To: Expert Consenting Panel – Environmental Protection Authority

From: Fraser McNutt/Steph Wilson – Barker & Associates Limited

Re: Ashbourne [FTAA-2507-1087] – Applicant Response to Minute 3

This memorandum has been prepared in response to a request received from the Ashbourne Expert Consenting Panel detailed in Minute 3, dated 21 November 2025. The Panel has requested clarification on several items which are addressed below.

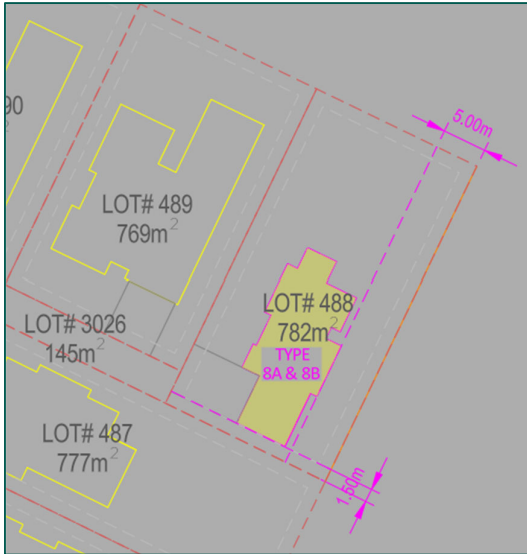
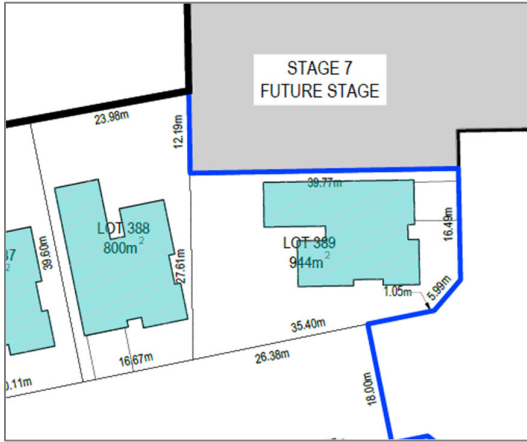
In addition, it is noted that an updated scheme plan has also been provided as Attachment 2 to correct an error in which Lot 384 was not labelled. No other changes have been made to the scheme plan.
